# Variance Request Form

Ocotillo Express Wind LLC  
Pier 1 Bay 3  
San Francisco CA 94111  
415-283-4000

# OCOTILLO WIND PROJECT: IMPERIAL COUNTY, CALIFORNIA

## VARIANCE 19 - AUGUST 30, 2012

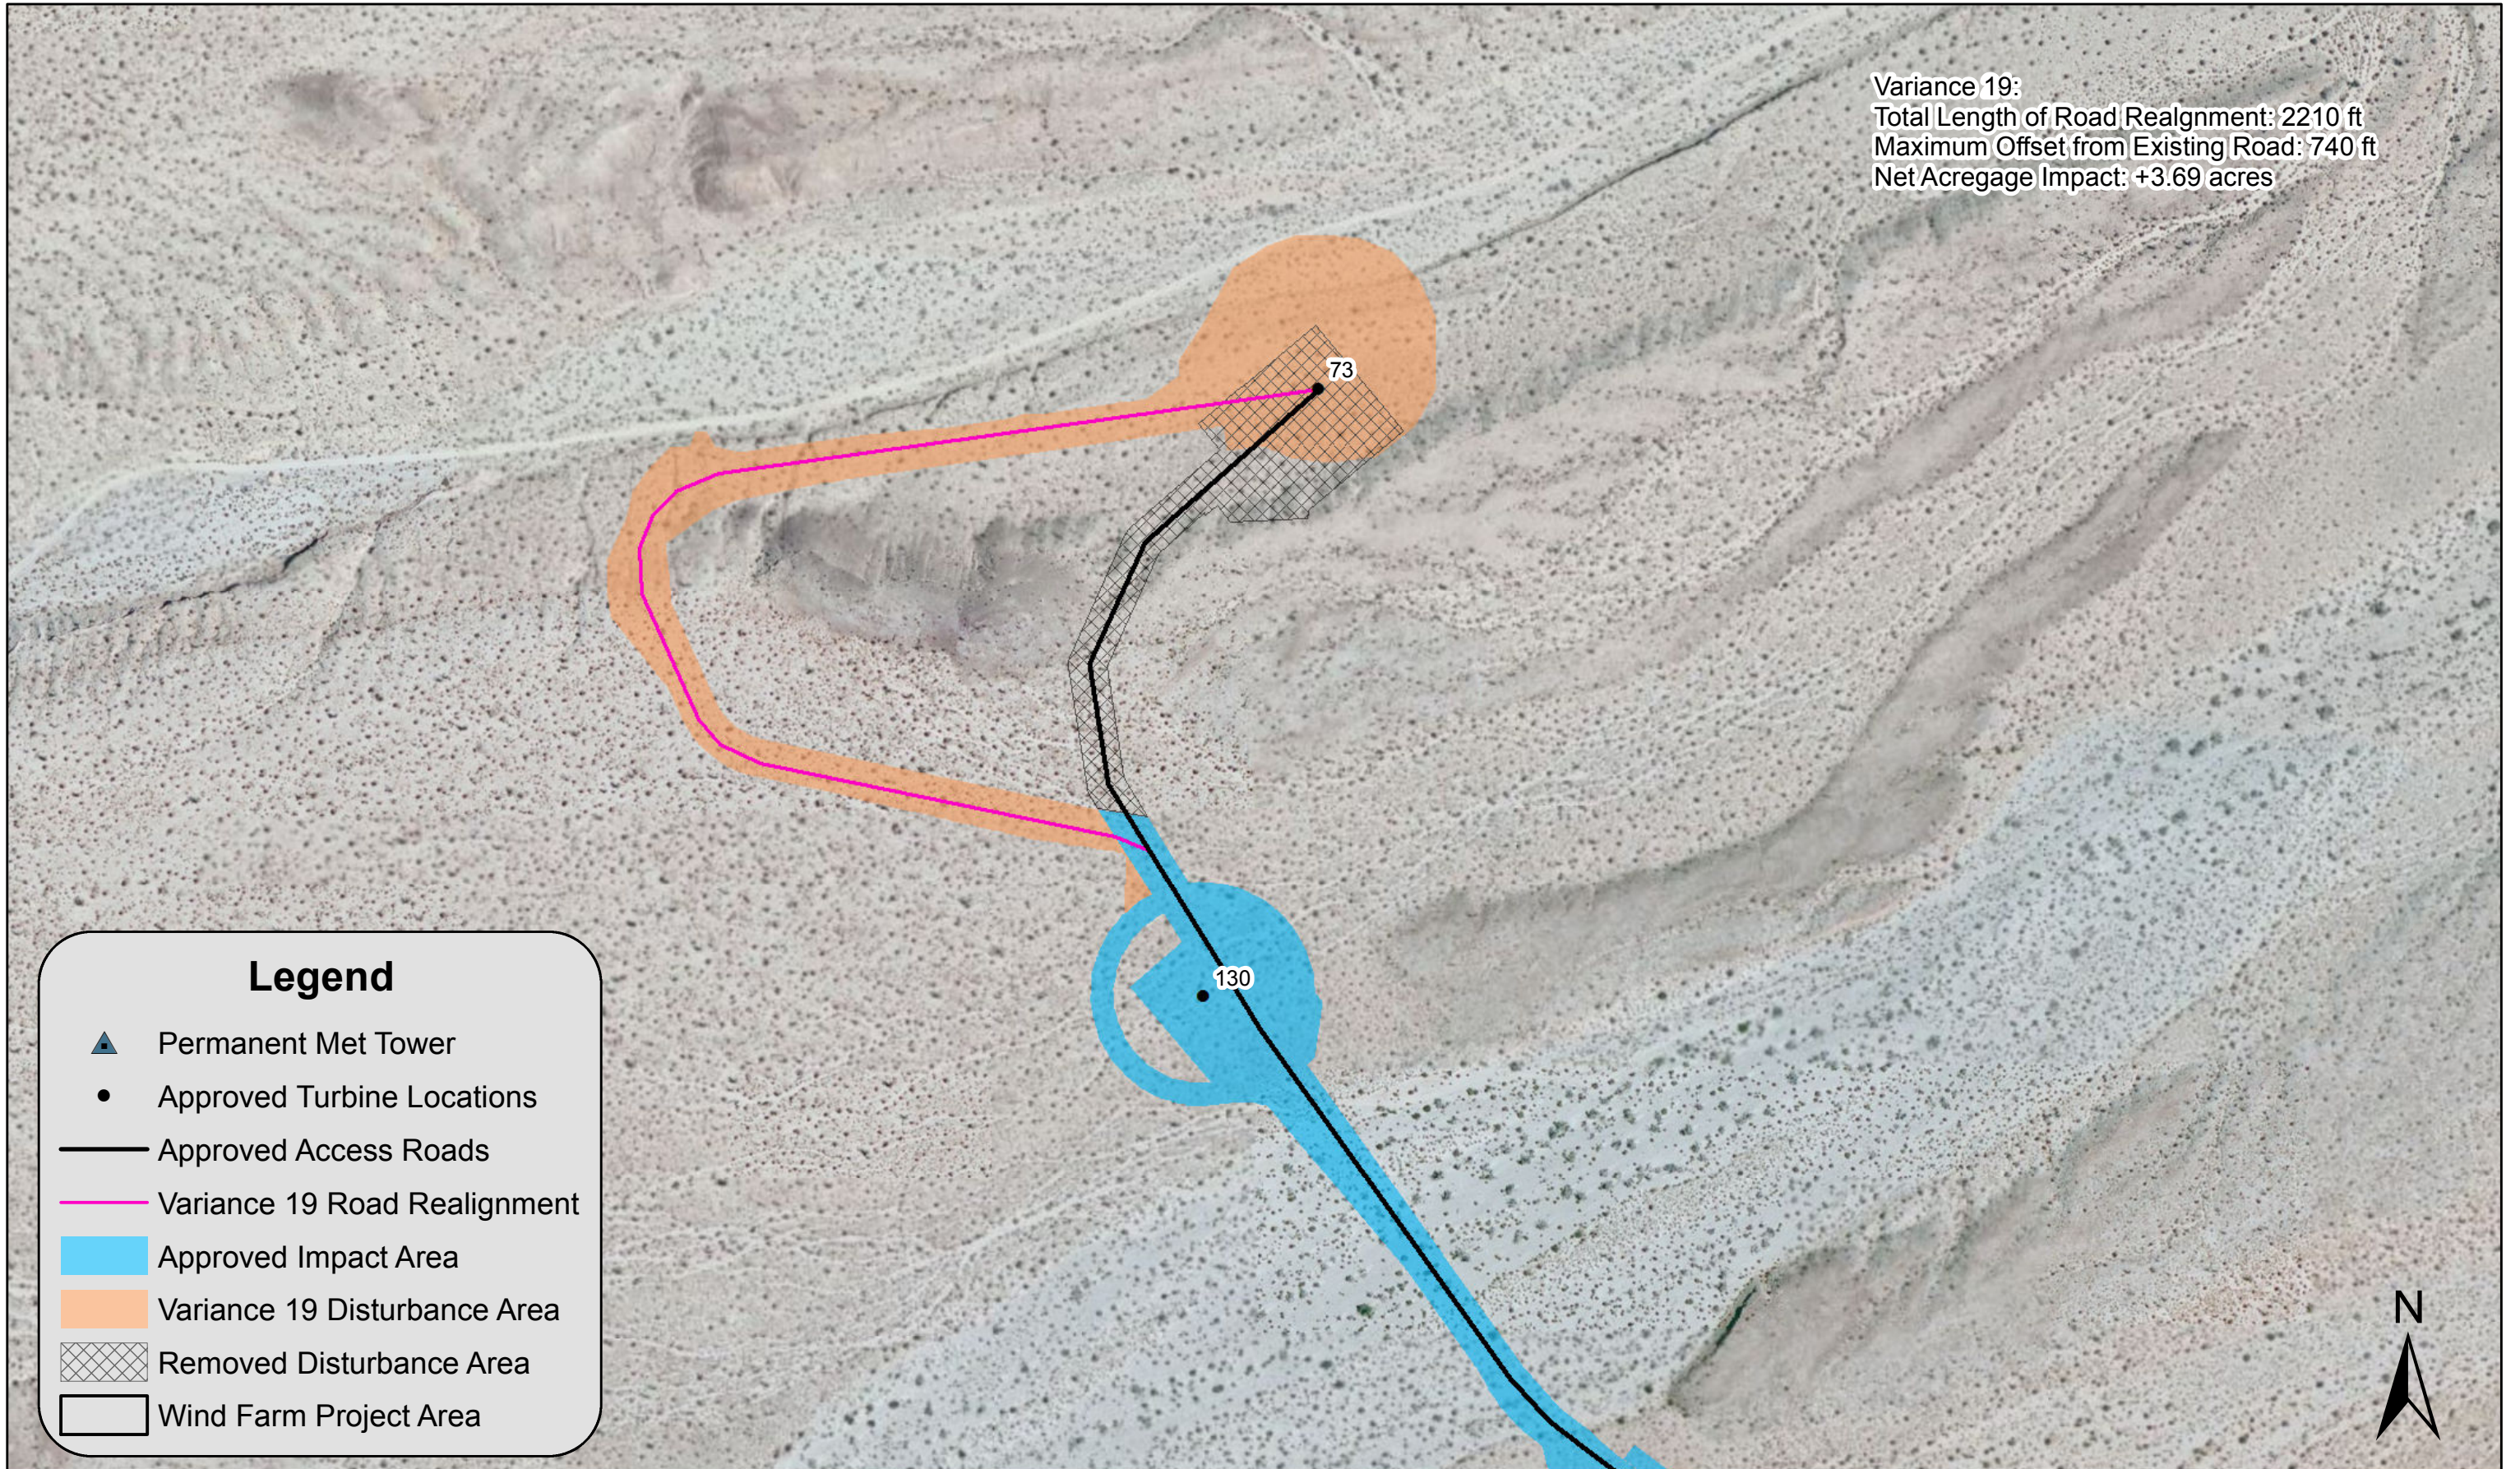
Variance 019 includes the realignment of the access road toward Wind Turbine 73 (see map attachment). The total length of the access road realignment is 2,210 feet with a maximum offset of 740 feet from the currently approved access road alignment.

Variance 19:  
Total Length of Road Realignment: 2210 ft  
Maximum Offset from Existing Road: 740 ft  
Net Acreage Impact: +3.69 acres
